FIRST DRAFT MINUTES

February 17, 2022 Standards Committee Meeting

REVISION TO STANDARD SPECIFICATIONS, SPECIAL PROVISIONS, AND STANDARD DRAWINGS

E 715-BKFL-01 PIPE BACKFILL METHOD 1 NEW ROADWAY, TRENCH (shown markups)

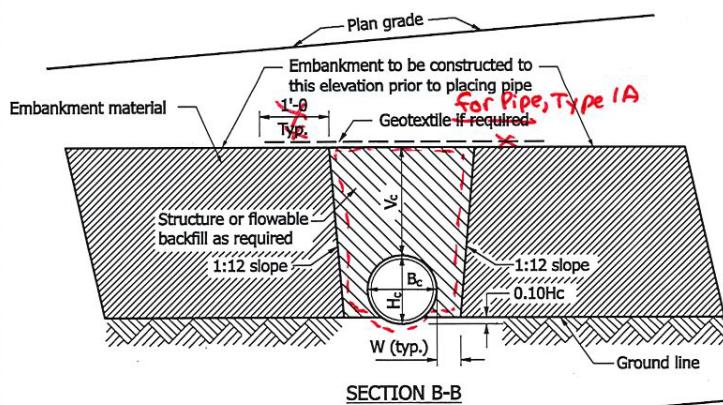
PROBLEM(S) ENCOUNTERED: Currently the Standard Drawing Series 715-BKFL only shows the geotextile capping structure backfill of pipes to prevent infiltration.

PROPOSED SOLUTION: Infiltration can occur anywhere around the structure backfill, therefore for, in most locations, structure backfill should be lined and capped. Have all type 1, 2, 3, and 4 structure backfill for pipes lined and capped with geotextile. Where flowable fill is used in lieu of structure backfill geotextile will not be required. In addition, all the geotextile material to be used to line and cap a pipe will be paid for as Geotextile for Pipes.

E 707-BPBF-01 FABRICATION TOLERANCES PRESTRESSED BOX BEAM (shown markups)

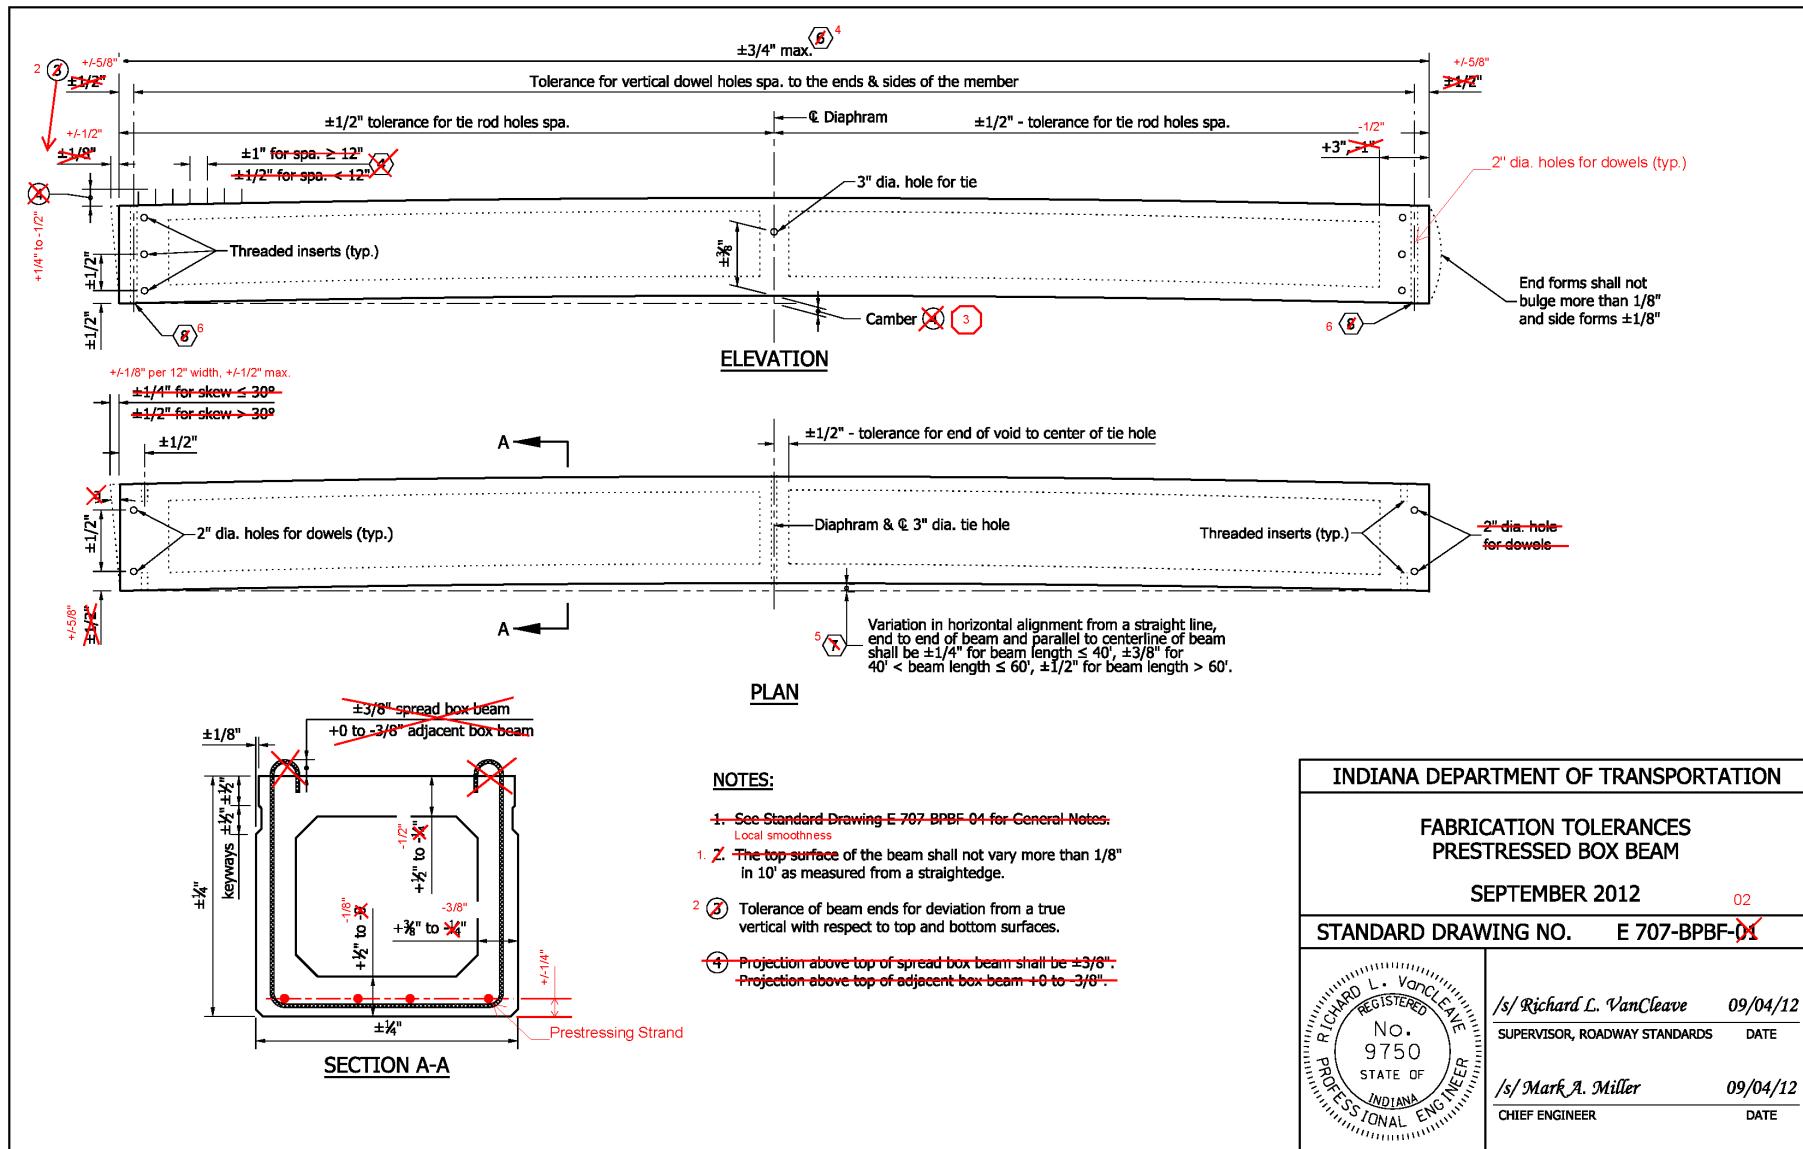
PROBLEM(S) ENCOUNTERED: The E 707-BPBF series Standard Drawings were last published in 2012 and are not in the current format for Standard Drawings. The current sheet 03 shows tolerances for the placement of lifting loops, which are determined by the manufacturer and are not detailed on the design plans. This has caused confusion and delays in the shop drawing review process.

PROPOSED SOLUTION: Several minor changes to the fabrication tolerances are being proposed in order to provide more consistency with the Precast/Prestressed Concrete Institute Tolerance Manual for Precast and Prestressed Concrete Construction, First Edition, Fourth Printing. Since the tolerances for AASHTO I-Beam and Bulb-Tee Beams are the same, current sheets 02 and 03 are being combined into one sheet. The lifting loops that are currently shown on sheet 03 are being removed in order to avoid confusion related to the responsibility of detailing those items.

9. At concrete bearing area, deviation from plane surface when tested in all directions of the plane surface with a steel straightedge shall not be more than $+1/16"$ ~~$+1/16"$~~ $-1/8"$
